**The Legacy Way Project
Application for Project Change**

**Temporary Construction
Workforce Car Park
Scenic Drive, Mount Coot-tha
(revised) July 2011**

- **Figure 1-1 - Proposed Construction Workforce Parking Area at Scenic Drive (off Sir Samuel Griffith Drive)**

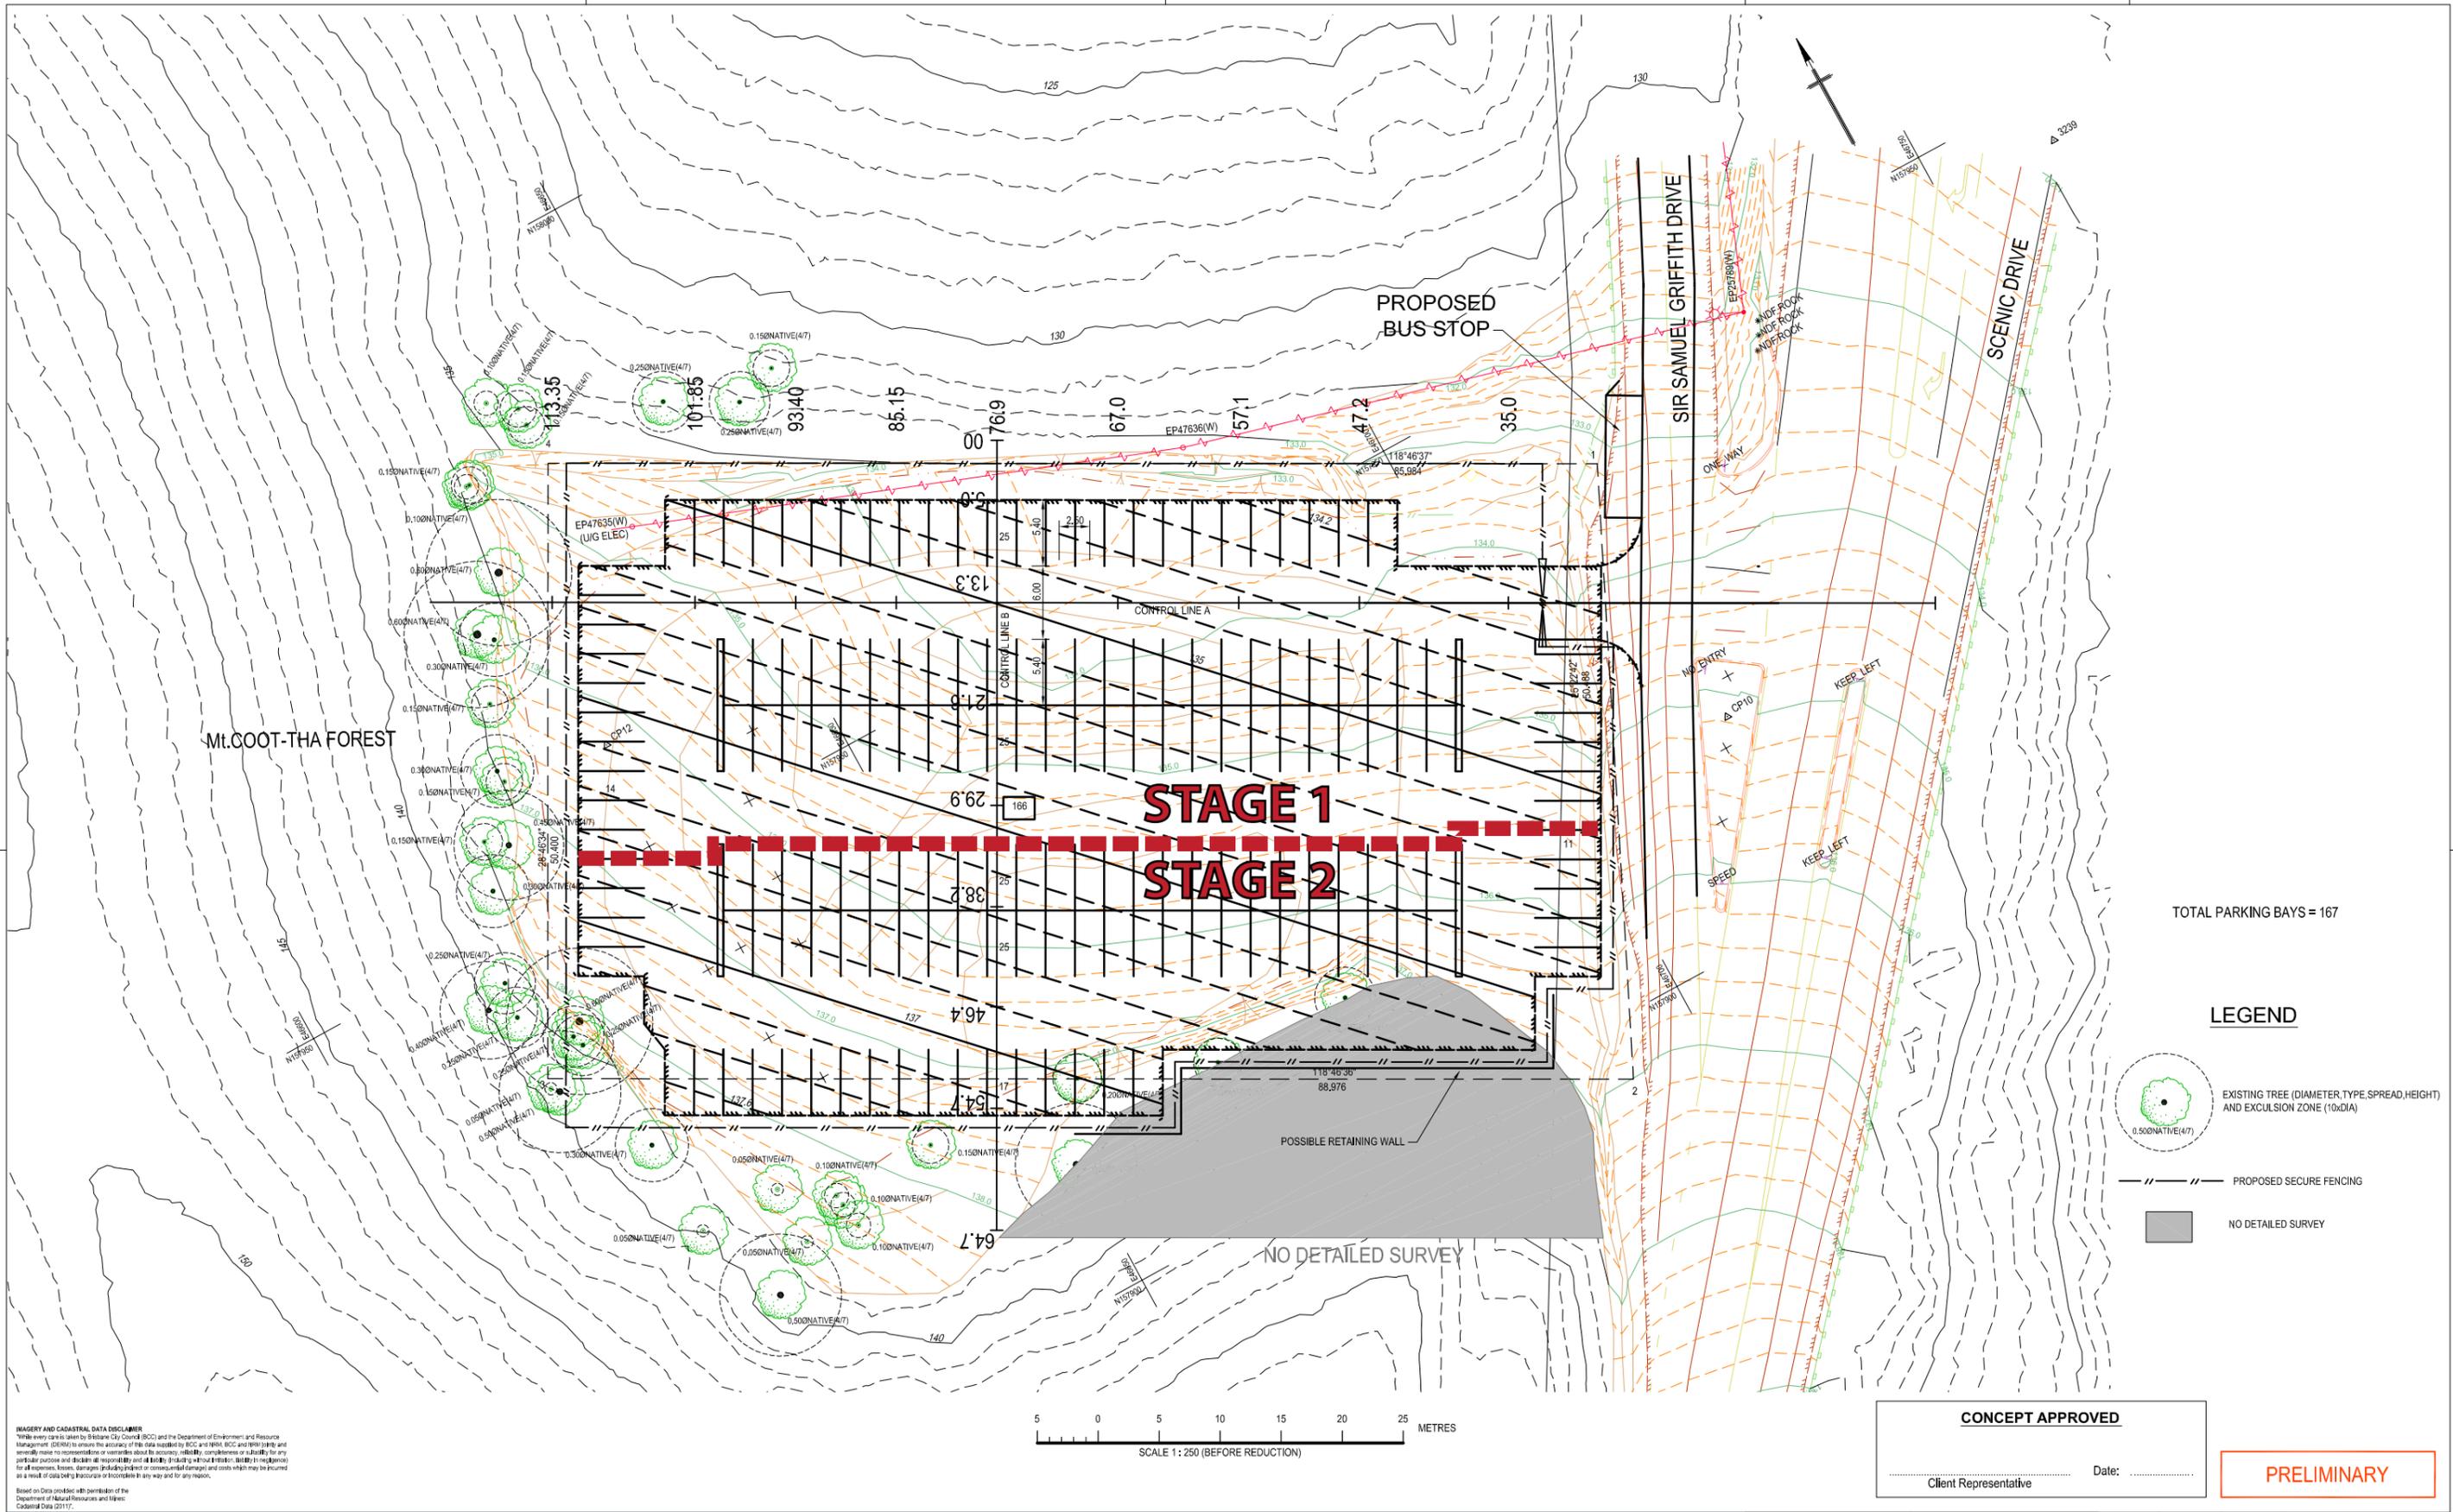
This application for project change is to establish a temporary construction workforce car park on the western side of Scenic Drive at its intersection with the existing one-way section of Sir Samuel Griffith Drive near Mt Coot-tha. The proposed car park would be used for both day and night construction workforce vehicle parking with access to the western worksite provided by a shuttle bus. The proposed car park layout for the temporary construction workforce car park is shown in **Figure 1-1** below.

The proposed car park layout for the temporary construction workforce car park provides for approximately 170 parking spaces (refer to **Figure 1-1**). A bay for shuttle bus pick-up/drop-off is located in the north east of the site, off Sir Samuel Griffith Drive.
